# Conceptual Review Agenda

Schedule for 04/25/16 to 04/25/16

# 2800 S Taft Hill Rd Multi-family

**Description of project:** This is a request to build a 170 unit, multi-family building at 2800 S Taft Hill Rd. (parcel #9727205004). The project will be an age qualified development targeted towards seniors. The development will contain 259 parking spaces and two courtyards for residents. The site is located in the Medium Density Mixed-Use Neighborhood (MMN) zone district. This proposal will be subject to Planning & Zoning Board (Type II) review.

**CONCEPTUAL SITE PLAN**  
SCALE = 1:100

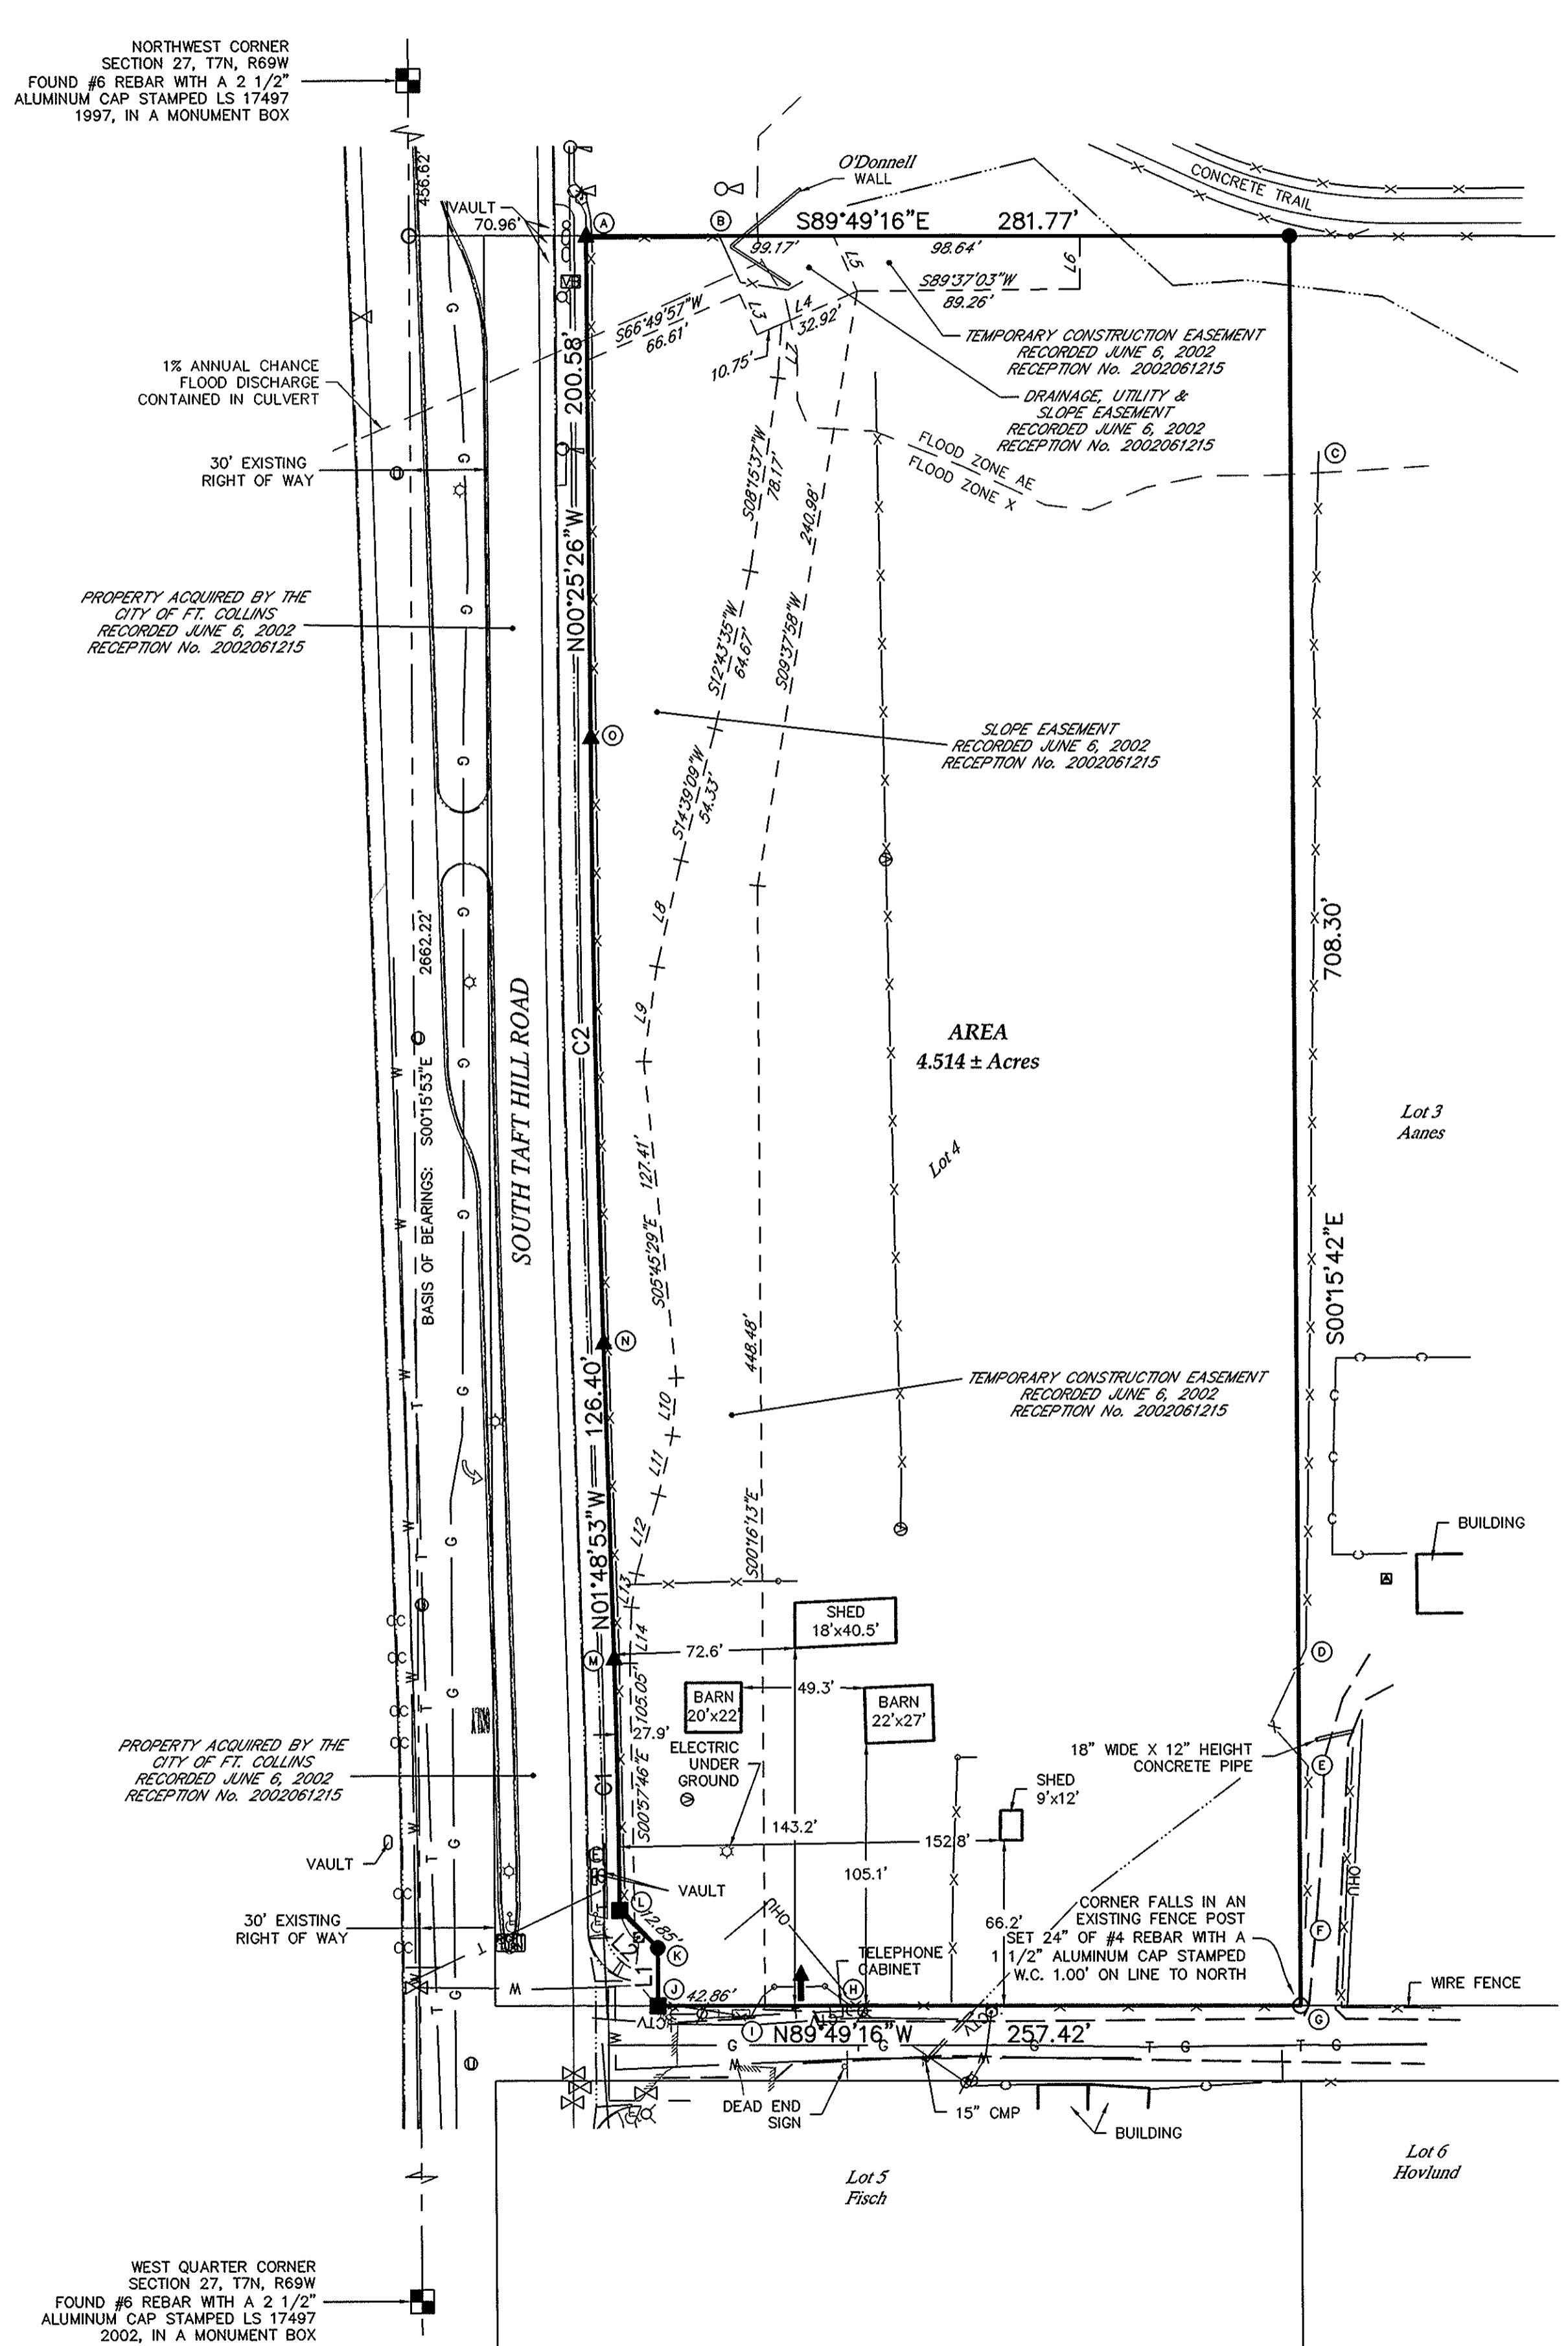
1. In addition to the buffer on the east (refer to planning comments) having the parking lot on east side will offer a better transition.
2. Any building over 40ft in height will require a shadow analysis.
3. Section 3.8.30 does apply (See section for details).

11. The materials submitted for review do not appear to show any lots or structures proposed within the flood zones. Please add the floodplain and floodway boundaries to all applicable drawings so that it is clear what improvements will be impacting the flood zones. Please contact Beck Anderson of Stormwater Master Planning at [banderson@fcgov.com](mailto:banderson@fcgov.com) for floodplain CAD line work.

Fire access is required to within 150' of all portions of the building's ground level perimeter. Fire access cannot be measured from an arterial road. At this time, it is unclear how the site plan will be able to achieve this need. Further discussion is warranted. Code language provided below.

Buildings exceeding 30' in height have additional requirements to enable ladder truck access to reach upper floors and provide roof access. At this time, it is unclear how the site plan will be able to achieve this need. Further discussion is warranted. Code language provided below or see Appendix D of the 2012 IFC for further details.

A fire hydrant is required within 300' of the building as measured along an approved path of vehicle travel. At this time, it is unclear if the site plan meets this requirement. Code language provided below.

4. The site plan doesn't show any bike parking. You will be required to provide one bicycle parking space per bedroom with 40% provided by fixed racks and the remaining 60% in enclosed locations. If you decide to provide bicycle parking spaces in the units, please submit floor plans that show where the bike racks are located within the units.

5. The site plan does not show any connections to the sidewalk along Taft Hill, Hull, or to the Spring Creek Trail. This project must provide connecting walkways to all of these amenities to ensure pedestrians can easily access the site and the surrounding areas.

6. Please show where the trash and recycling enclosure will be located on your site plan and landscape plan. Please also submit elevations of the enclosure to ensure it matches the architectural style of the project. The enclosure should be located on a concrete pad and should have a walk-in access that is separate from the main service gate.

8. This development must provide a 25 foot buffer yard along the east property line since it is adjacent to a single-family home. Please provide enhanced landscaping in this buffer yard to provide for a transition between your development and the adjacent property.
